[To:](#) Stanley.Lyles@fcc.gov
[Cc:](#)
[Bcc:](#)
[Subject:](#) Re: Fw: FCC Equipment Authorization System

Re: FCC ID: QISAP505130DN

Applicant: Huawei Technologies Co.,Ltd
Correspondence Reference Number: 46318
Form 731 Confirmation Number: EA154006
Date of Original E-mail: 08/20/2014

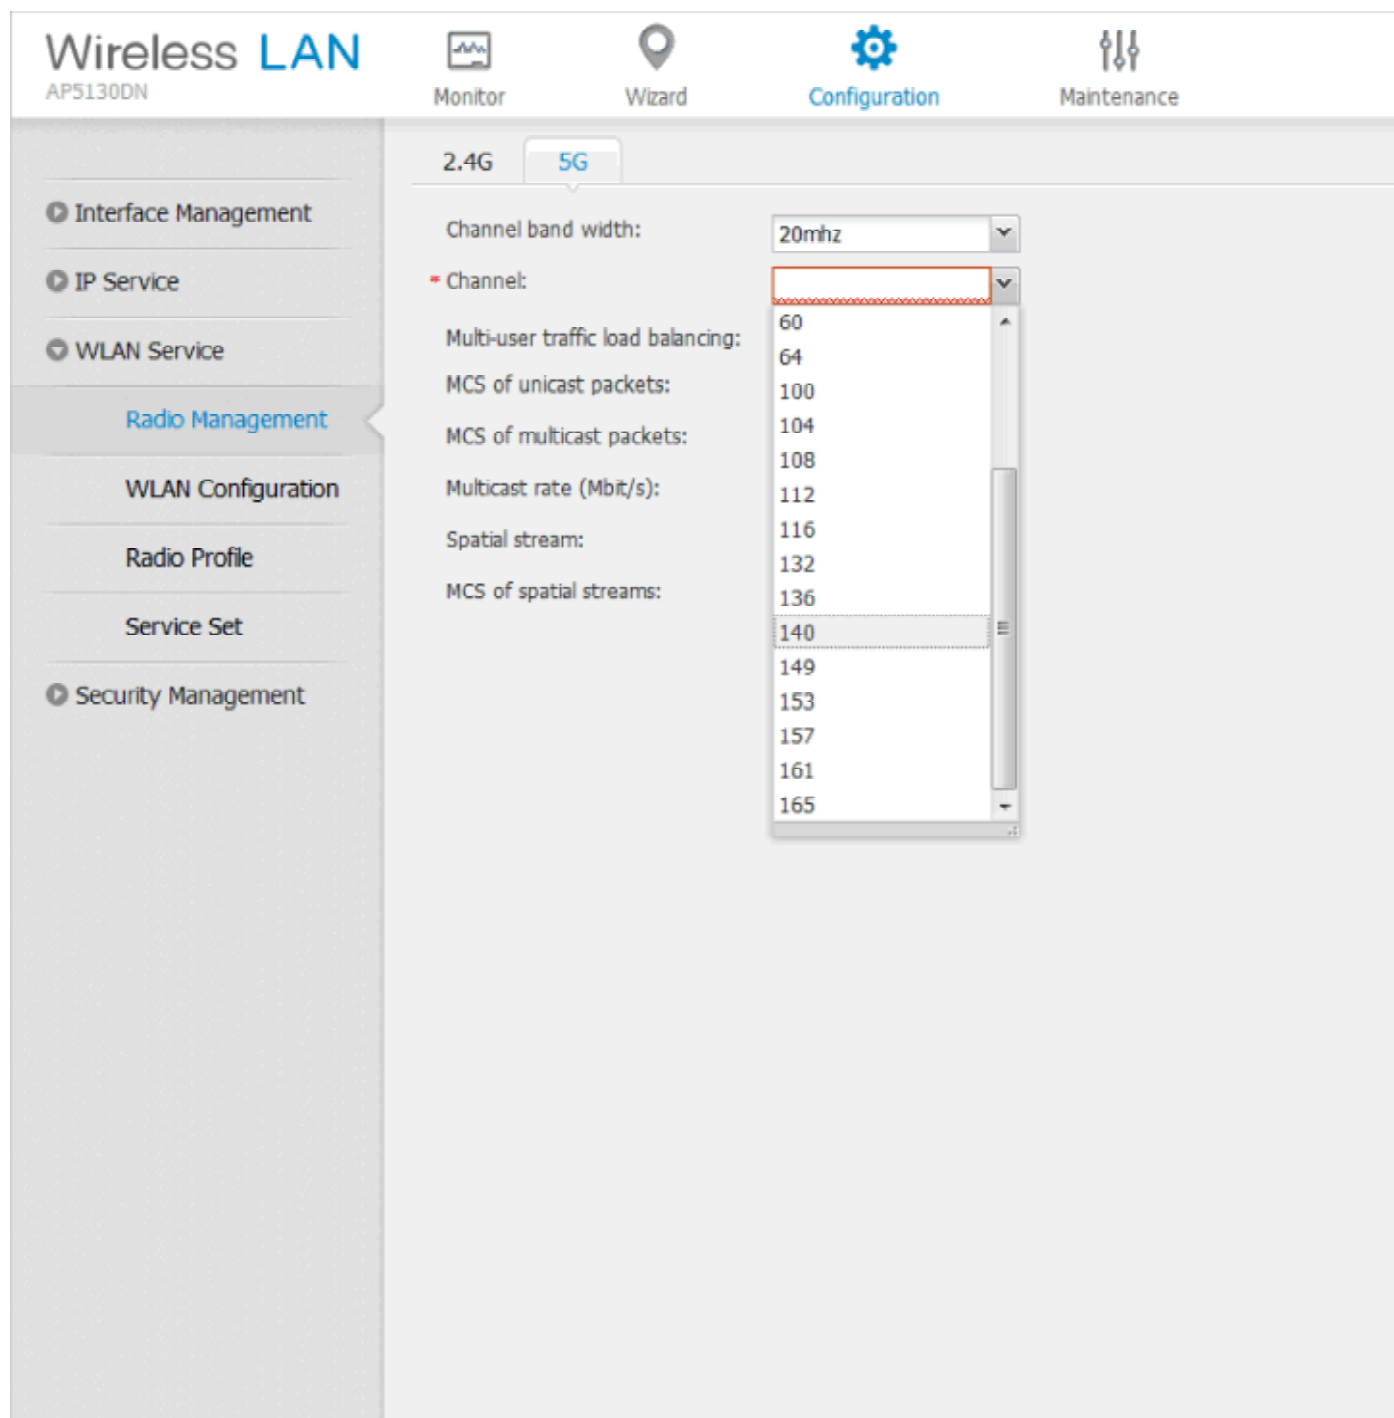
In the review of GUI we found that channel 144, 20 MHz was listed in the initial channel listing. The use of this channel is allowed under old rules. However, this must follow the KDB publication 644545 D01 Guidance for IEEE 802.11ac v01r02, sections E)3)a), F)2) and F)3) for compliance. Otherwise, this channel must be removed from the listing.

Thanks for your guidance! Sorry but we checked the GUI interface and found there is no channel 144 in the channel list, please see below scansht for your reference.

So we feel confused why this hanppened. Would you mind sending us a scansht for the channel 144?
